EASTERN CORRIDOR SEGMENTS II AND III (PID 86461)  
**COMBINED LINWOOD/EASTERN INTERCHANGE AND US 50/RED BANK INTERCHANGE FOCUS AREA**  
**ADVISORY COMMITTEE MEETING #2**  
R.G. CRIBBET RECREATION CENTER • MAY 22, 2018

## MEETING #2 NOTES

**Figure X-2B-1**  
SINGLE POINT URBAN INTERCHANGE

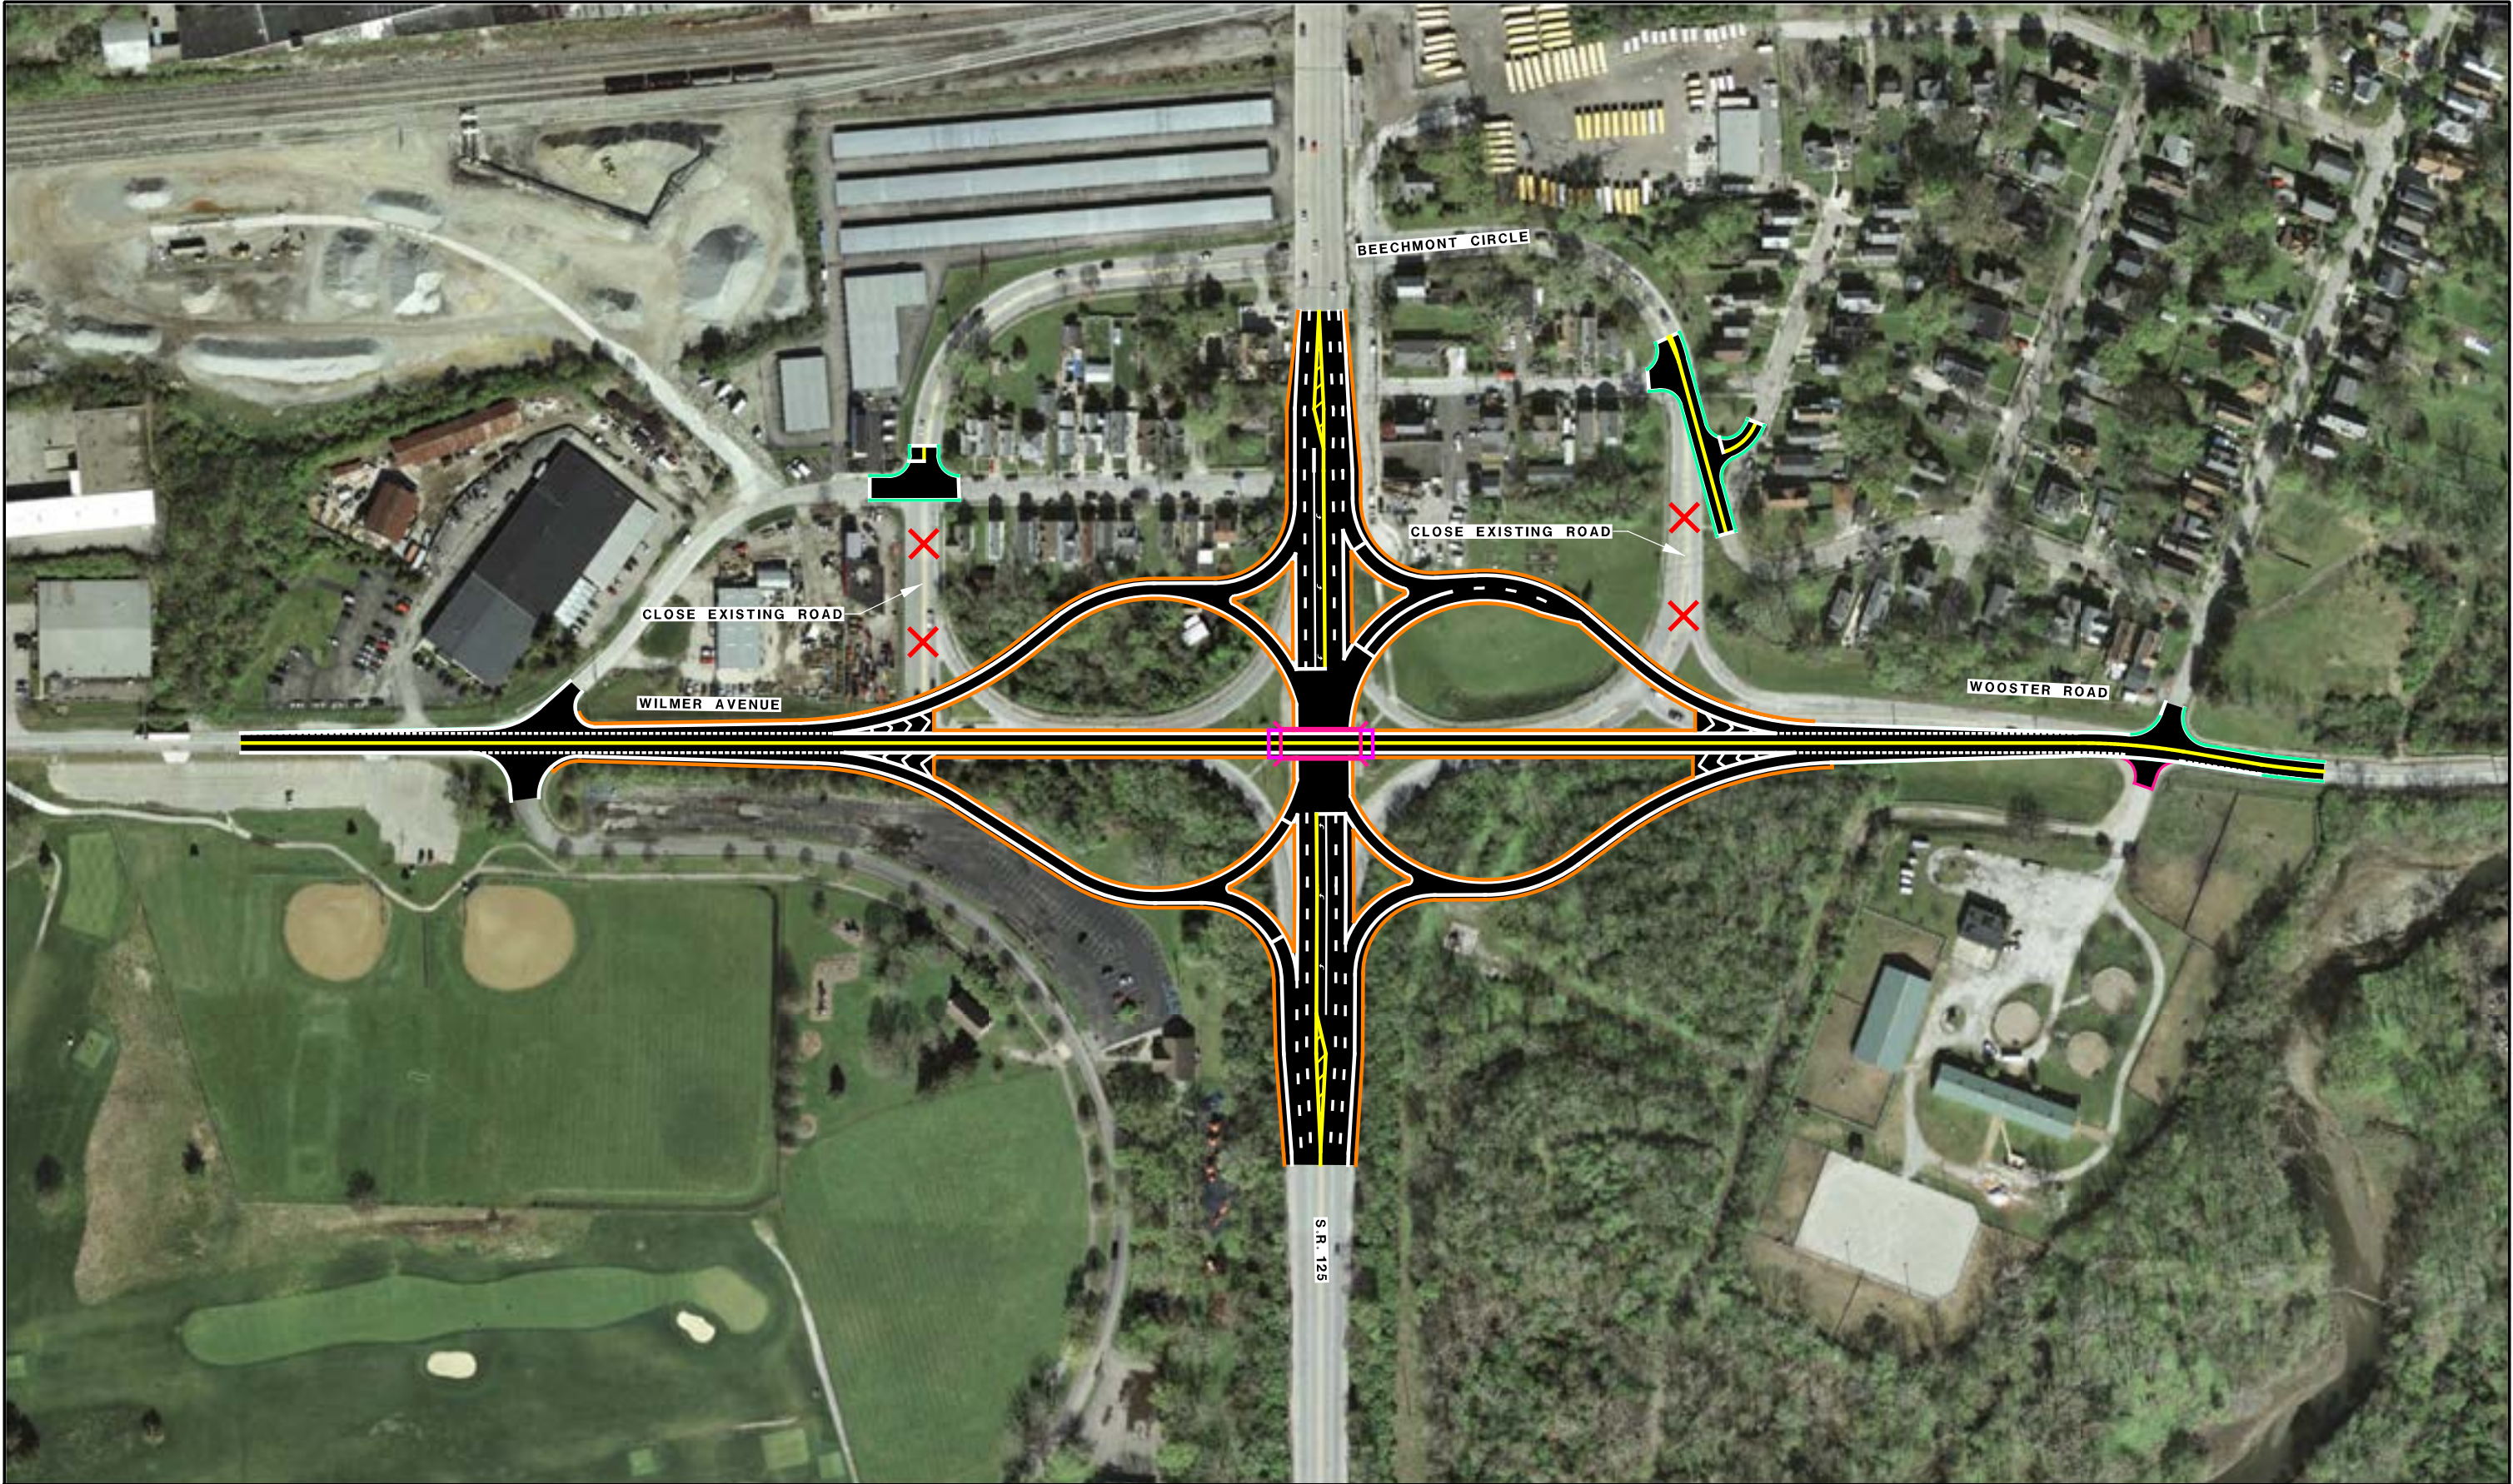
- A traffic signal would be installed on the lower level.
- Initial analysis indicates that the traffic signal required on SR 125 would not perform well.
- The concept requires construction of a significant structure that yields low benefit.

**Figure X-2B-2**  
**GRADE SEPARATED INTERCHANGE TO CONNECT  
 WILMER AVENUE TO WOOSTER ROAD**

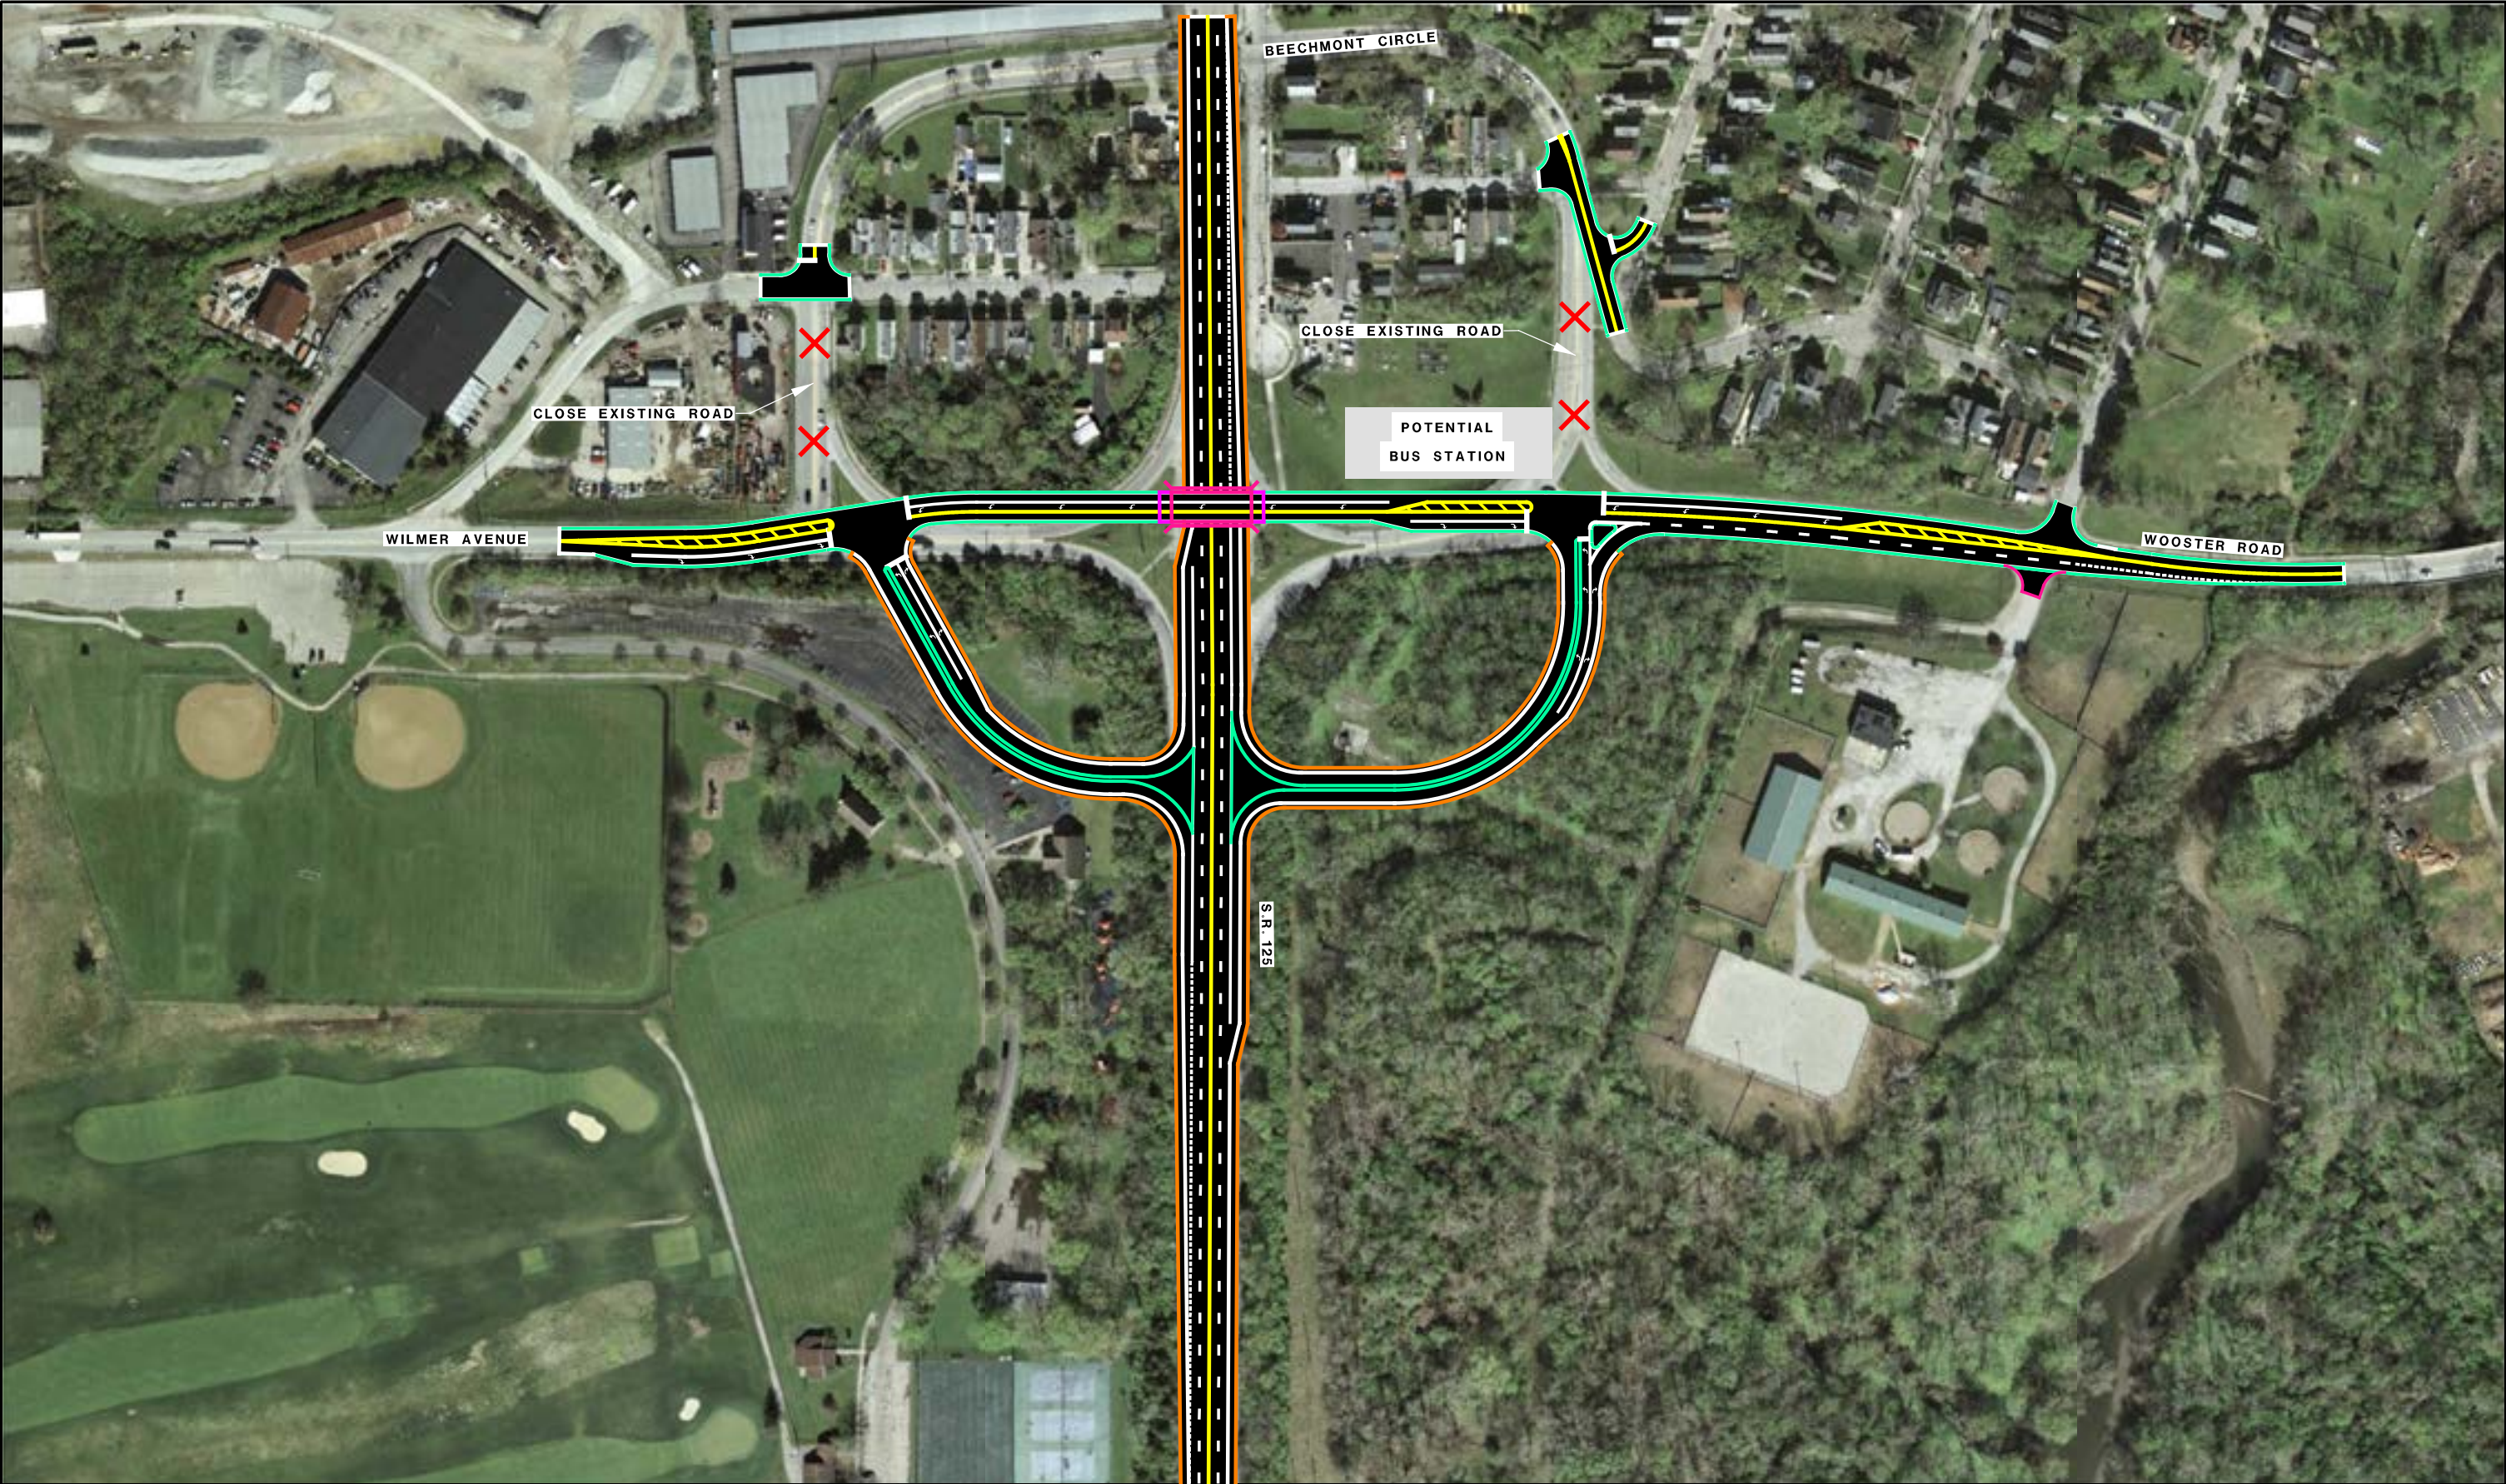
- This concept offers a lower speed connection to Wilmer Avenue and Wooster as compared to concept X-2b-3.
- The Wooster/Wilmer interchange would travel over SR 125.
- Offers a clear connection between Wilmer and Wooster.
- Concept would take through-traffic off Beechmont Circle and return the roads back to the neighborhood.
- Would need to add a turn lane to Hutton Street from Wooster.
- Concept would impact the locations of existing bus stops; bus stops would have to be relocated.

- Will the 3 way intersections on either side (East and West) of the proposed grade change connection of Wilmer and Wooster be signalized, or stop signs? Concern this will slow flow of traffic compared to current design

- The intersections would either be signalized intersections or reconfigured into roundabouts.
